Docket Item # 4
BAR CASE # 2008-0201

BAR Meeting
November 19, 2008

ISSUE: New mixed-use building
APPLICANT: Harrison Holdings LLC (John Marino)
LOCATION: 1123 Queen Street
ZONE: CL/Commercial Low

Figure 3: Front Elevation

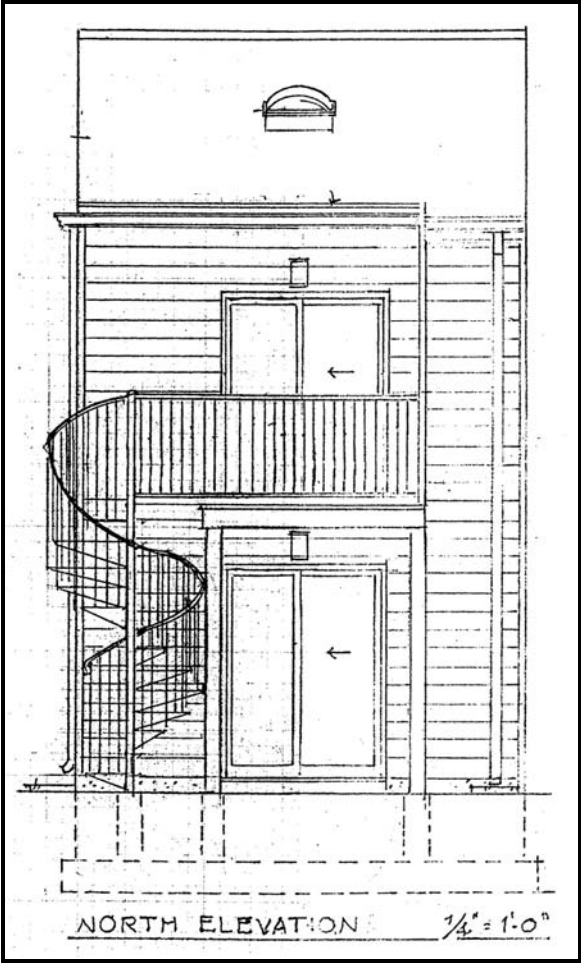
Front (south) Elevation – The front elevation of the building will be two bays wide with a front mansard roof and a sloping rubber membrane roof behind. The first floor will have a full light wood door with a two-light transom and a projecting bay window. The bay window will project almost 2' from the plane of the building and will have a wood cornice and two wood panels beneath. The glass on the front of the bay will be separated by a 1 1/8" wood muntin bar. The two Kolbe and Kolbe wood windows on the second floor will have a two-over-two light pattern, and will be double insulated with true divided lights and 1 1/8" muntins. This muntin width matches both the bay window and the historic windows on the adjacent house at 1119 ½ Queen Street. The building cornice will have dentils and three brackets, not unlike the Italianate house next door, and will be constructed of wood and Fypon. The house will be clad with smooth Hardiplank siding in a Navajo beige color (the applicant has provided a color sample which will be available at the hearing). The standing seam metal mansard roof will be black and the trim throughout will be white. The front door will be stained. The house will sit on a concrete foundation and will have grass in the front, with the exception of the concrete walk leading to the building entrance. The trim on the front of the house will be wood, with the exception of the Fypon (a type of urethane millwork) used on the building cornice.

Thus, the use of fiber cement on this new building is in conformance with the Board's policy, provided that the smooth fiber cement siding be installed so that the nails do not show. Staff also has no objection to the use of Fypon on the upper cornice because it will be located 19' above street level. The Trex material proposed for the rear deck will not be visible from a public right-of-way.

1. That the nails not show in the installation of the smooth Hardiplank siding;
2. That a low or flat profile glass skylight be installed instead of the proposed acrylic dome skylight;
3. Call Alexandria Archaeology immediately (703-838-4399) if any buried structural remains (wall foundations, wells, privies, cisterns, etc.) or concentrations of artifacts are discovered during development. Work must cease in the area of the discovery until a City archaeologist comes to the site and records the finds; and,
4. The above statement must appear in the General Notes of all site plans and on all site plan sheets that involve demolition or ground disturbance (including sheeting and shoring and grading) so that on-site contractors are aware of the requirement.

Figure 4: Rear Elevation

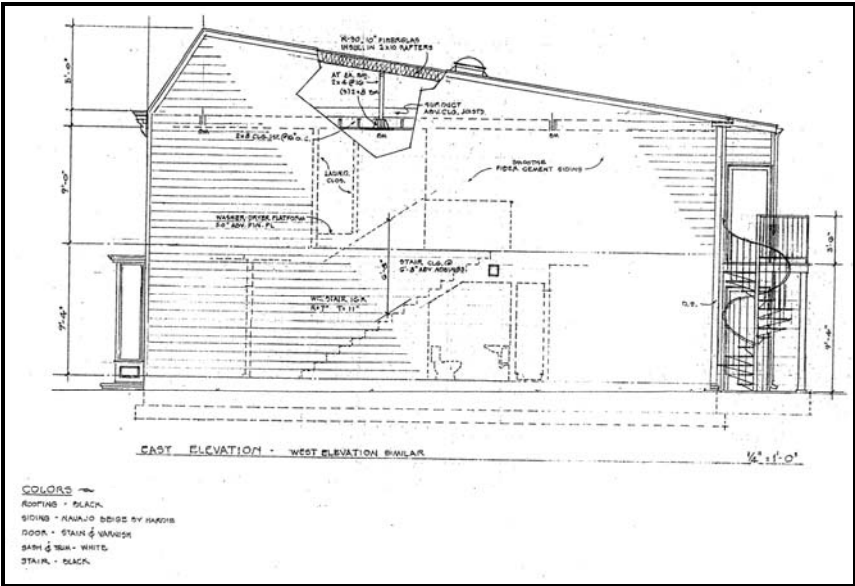
Rear (north) Elevation – The rear elevation will have full light sliding glass doors centered on each floor and a projecting two-story 3'6" by 3'6" mechanical enclosure. The second story deck will measure roughly 5' by 6' and will have a black metal railing and spiral stairs providing access to the ground floor. The deck will be constructed of Trex, a composite material of wood and vinyl and the gutters and downspouts will be aluminum. A domed skylight will be installed on the rear slope of the rubber roof. The applicant does not intend to install a fence to enclose the rear yard. The rear elevation will be minimally, if at all, visible from the alley in the center of the block.

While the Boards generally discourage the use of spiral stairs, the *Design Guidelines* state that they are "...appropriate for late-20th century buildings and should be inconspicuously located." Staff has no objection to the stair because it will not be visible from the rear and only a small portion – 1 foot – projects beyond the building wall and will be visible from Queen Street. To comply with the *Guidelines* as they relate to skylights, Staff recommends that a low or flat profile glass skylight be used instead of the proposed acrylic dome skylight.

Figure 5: Side Elevation

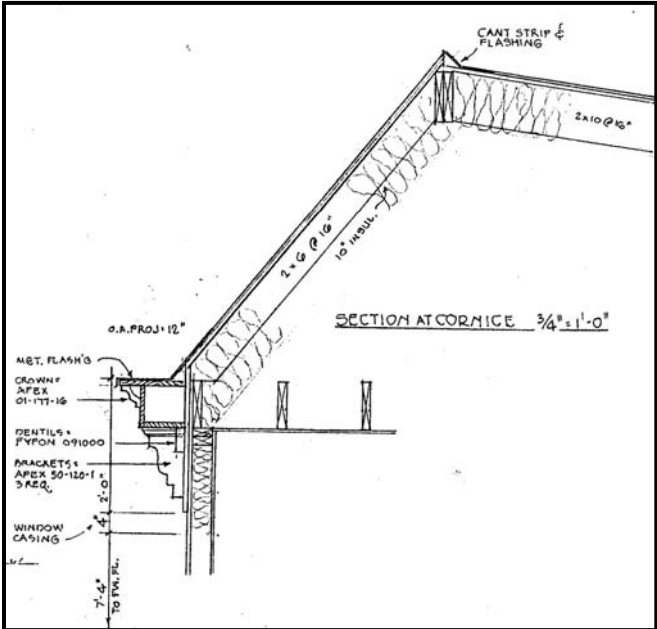
Side (east and west) Elevations – Neither the east or west elevation will have any penetrations. The side elevations will be minimally visible between the 2' and 3' gaps separating the subject property from the adjacent buildings. Two electric meters will be installed on the east elevation where they will be minimally visible.

- C-1 All exterior walls within 5 feet from an interior property line shall have a fire resistance rating of 1 hour, from both sides of the wall. As alternative, a 2 hour fire wall may be provided. This condition is also applicable to skylights within setback distance. Openings in exterior walls between 3 and 5 feet shall not exceed 25% of the area of the entire wall surface (This shall include bay windows). Openings shall not be permitted in exterior walls within 3 feet of an interior lot line.
